PROPERTY INFORMATION			
Project/Property Address: Buckles Court North (Lot 2)		Project Name/Business Name: Crescent at Central Park- Lot 2	
Parcel #: 025-013773-00	Zoning: (see <i>Map</i> )	<b>SCPD</b>	Acreage: 3.84 acres

PLAN SPECIFICATIONS
Project Description & Proposed Use(s): 2 story medical office building, parking and utilities.

Subject: Crescent at Central Park Section 2- Lot 2  
City of Gahanna, Franklin County, Ohio  
CEC Project 314-902

RE: Project Buckles Court North (Lot 2) Final Development Plan

DRAWING NO:  
**C200**  
SHEET 1 OF 1

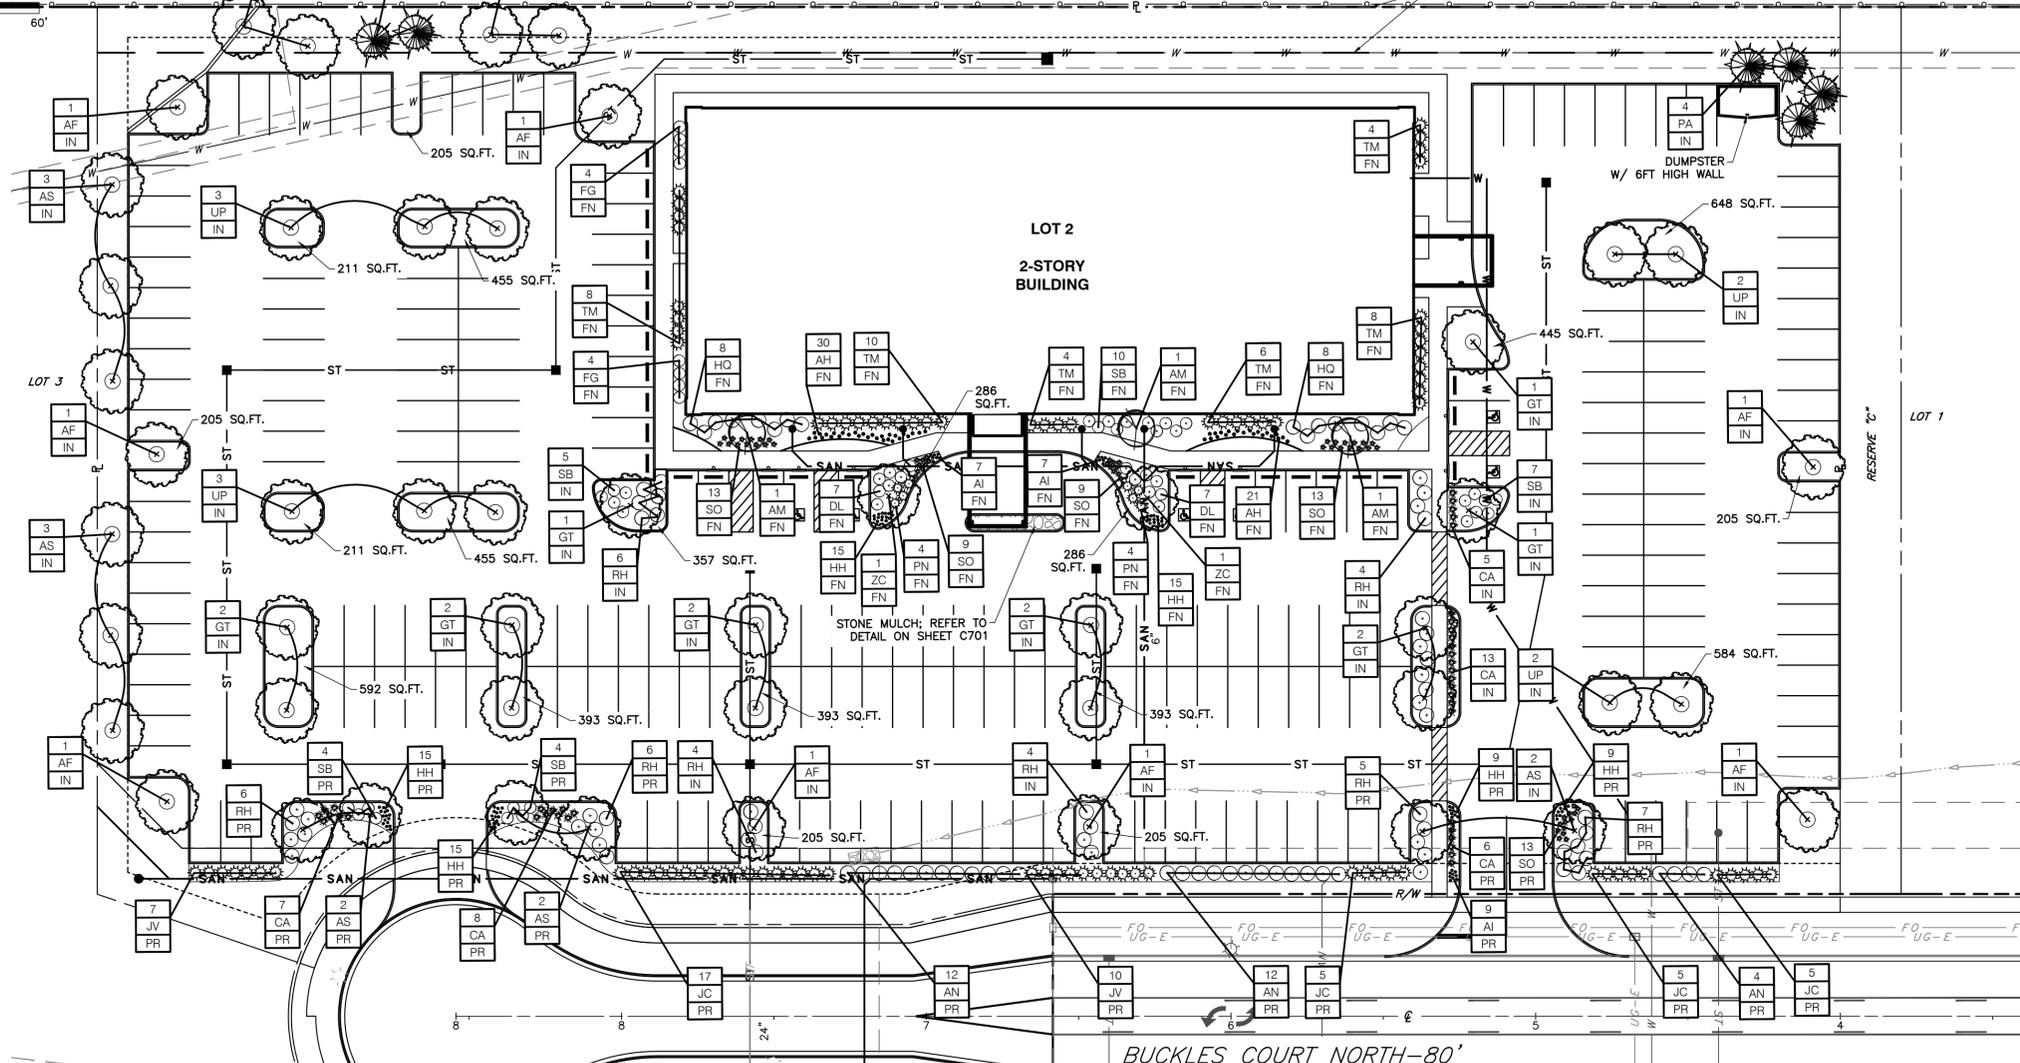
3. Parking for medical uses are based on the number of exam rooms and the amount of staff. Please see CH 1163.02(a) for details and please revise accordingly.  
**Parking data has been revised based on exam rooms and largest shift.**

4. Please revise the site statistics table to include building height. It appears the proposed two story building will meet code requirements, however the height in feet needs to be included.

**The building height has been added to the site statistics table.**

**DETAIL 700 - SHADE TREE PLANTING DETAIL**  
NOT TO SCALE

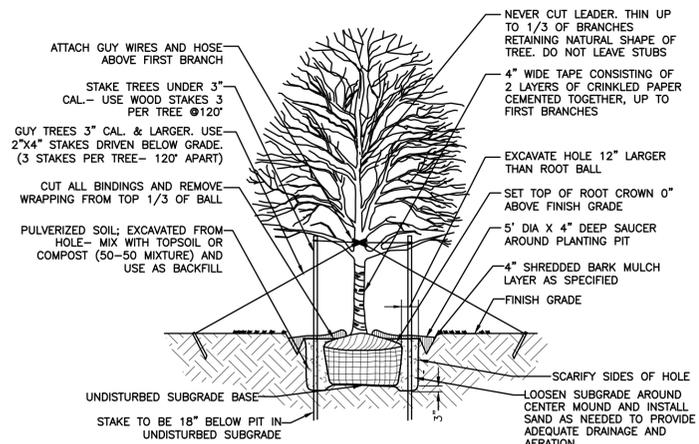
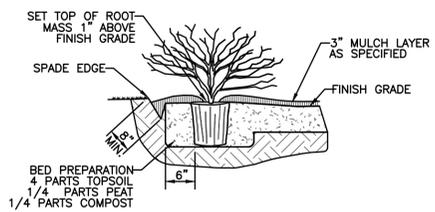
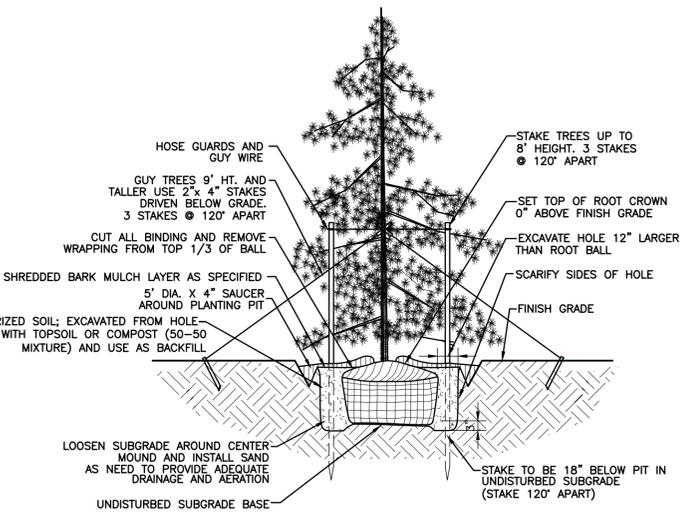
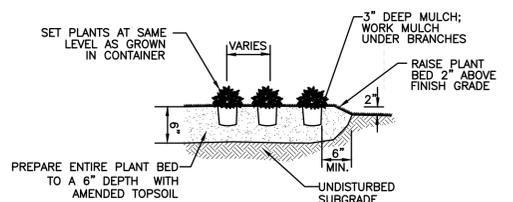
6. Species selection looks acceptable. I was worried about the “bush honeysuckle” at first glance, but I see that it is Diervilla spp. instead of Lonicera spp. It does not look like Diervilla spp. show invasive tendencies at this time. Planting details need to be adjusted to show root flare even with finished grade instead of top of root crown 4”

above finish grade. Mulch should be pulled away from the trunks of trees. Top 1/3 of burlap and metal basket should be removed from the root ball at a minimum.

**Planting details have been updated.**
